The Commission has issued the enclosed Amendment No. 79 to Facility Operating License No. DPR-50 for Three Mile Island Nuclear Station, Unit No. 1 (TMI-1). The amendment consists of changes to the Technical Specifications (TSs) in response to your request dated September 7, 1982 (TSCR 117), as modified by your letter dated September 17, 1982.

THREE MILE ISLAND NUCLEAR STATION, UNIT NO. 1

Amendment No. 79
License No. DPR-50

ATTACHMENT TO LICENSE AMENDMENT NO. 79

FIGURE 6-2

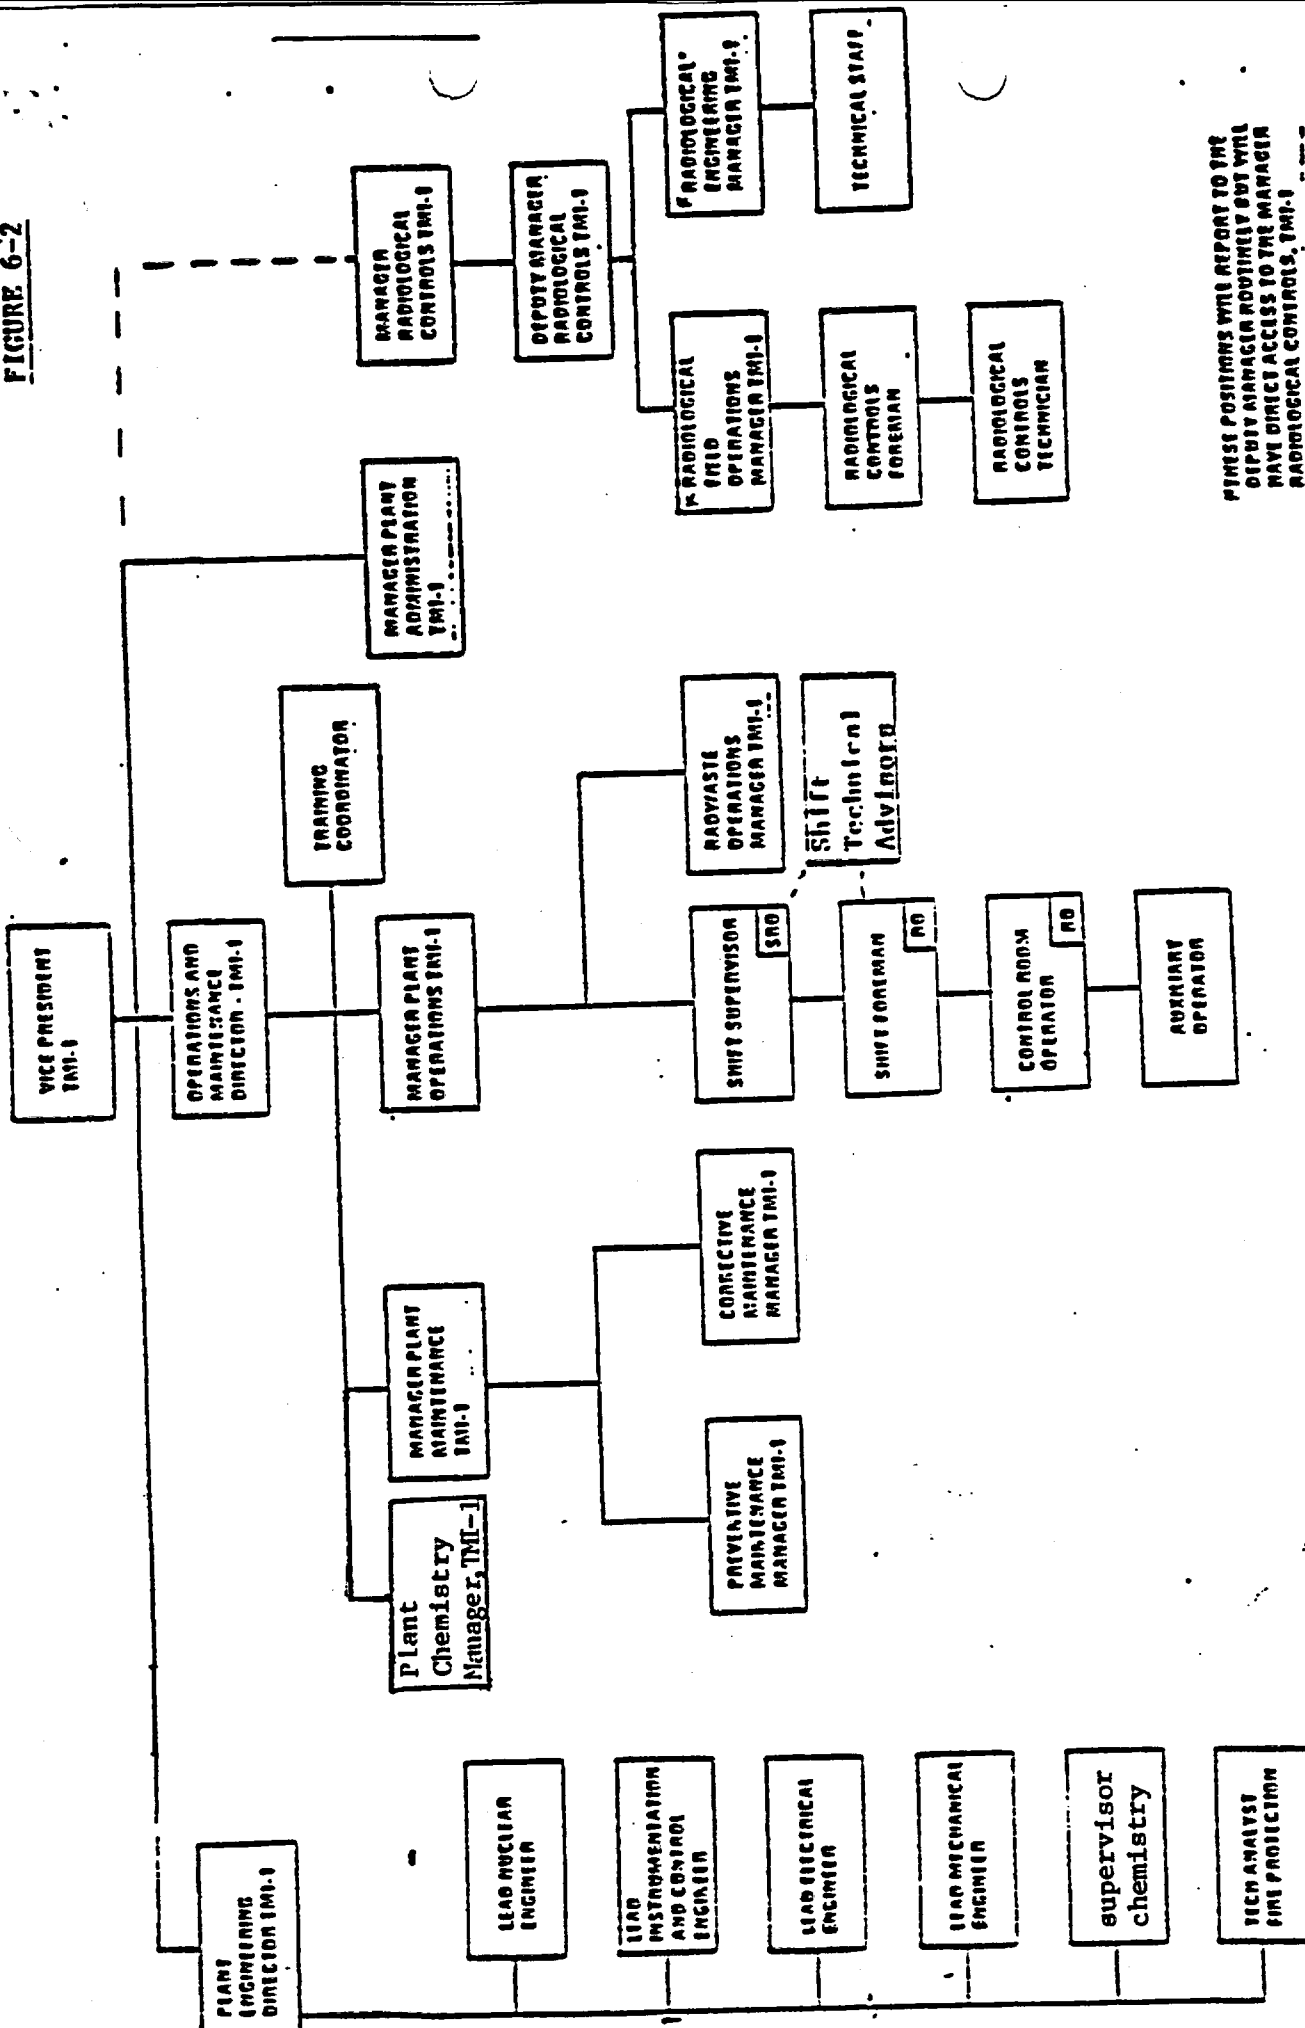
The amendment, which involves an administrative change only, revises the TSs to incorporate revised Figure 6-2 identifying the TMI-1 onsite organization. The figure has been revised to incorporate a new Plant Chemistry Manager who reports to the Operations and Maintenance Director, TMI-1. The functions under the Plant Chemistry Manager's responsibility have up until now been performed under the Chemistry Supervisor's responsibility who presently reports to the Plant Engineering Director. We agree with your position that because plant chemistry issues are closely related to day-to-day plant operations, it is logical to have the Chemistry Manager report to a director responsible for plant operations. We note also that the Plant Engineering Director will continue to have chemistry expertise available to him to provide technical assistance. We conclude that the proposed administrative change is acceptable.

The amendment revises TS Figure 6-2, TMI-1 Onsite Organization, to incorporate a new Plant Chemistry Manager who reports to the facility's Operations and Maintenance Director.
